SERVICE BULLETIN

M-1408B August 7, 2015

2014-2015 TOURING SADDLEBAG MOUNT - SAFETY RECALL 0166

Reason for Revision

Figure 1. Saddlebag Stud Receptacles (shown inverted from installed position)

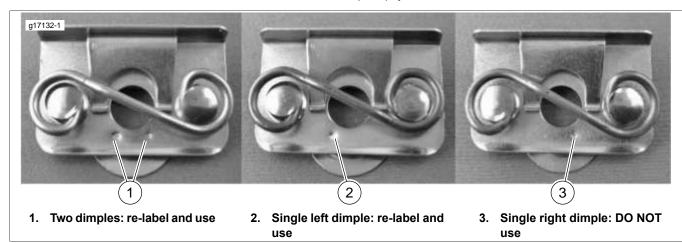
Harley-Davidson has learned that certain 0166 Recall Kits (Part No. 91500084) may have a quality issue. **Do not install kit 91500084 until kit inspection is complete.**

- 1. Inspect all dealer inventory of kit 91500084.
 - a. If package has a date code of 07/15/15 or earlier, parts are good. Add an "A" after the part number.
 - b. See Figure 1. Inspect all later date code inventory of kit 91500084 as shown in the graphic.
 - Add an "A" to all kits that pass inspection.
- For kits that fail inspection, see 91500084 KIT RETURN PROCESS.

2. If recall kit package has date of 7/15/2015 or later than please sort per the attached photos, facing the spring side, clip opening down as shown.

Two Dots are good to use. Add "A" to the Part No. Kit is ready for use.

Left Dot is good to use. Add "A" to the Part No. Kit is ready for use.

Right Dot only **DO NOT USE**.

Figure 2. Saddlebag Stud Receptacles

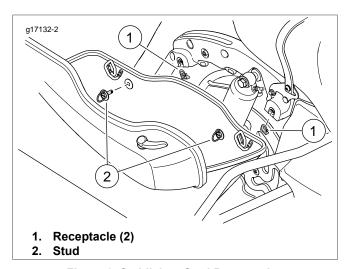
These model motorcycles built during the above date range may experience a failure of the saddlebag retaining receptacle. This may allow the mounting stud to disengage from the receptacle. If this condition remains undetected, the saddlebag may become separated from the motorcycle while it is in motion, possibly creating a hazard for other motorists.

- 1. Verify that the motorcycle is involved in this recall.
- See Figure 2. Remove saddlebags.
- 3. Remove receptacles (1).
 - Insert a small screwdriver between receptacle clip and edge of saddlebag support.
 - b. Pry receptacle from saddlebag support.
- 4. Install **new** receptacles supplied in kit.
- 5. Install saddlebags using original studs (2) and washers.
- Confirm that stud has been rotated a full 90 degrees to ensure complete engagement.
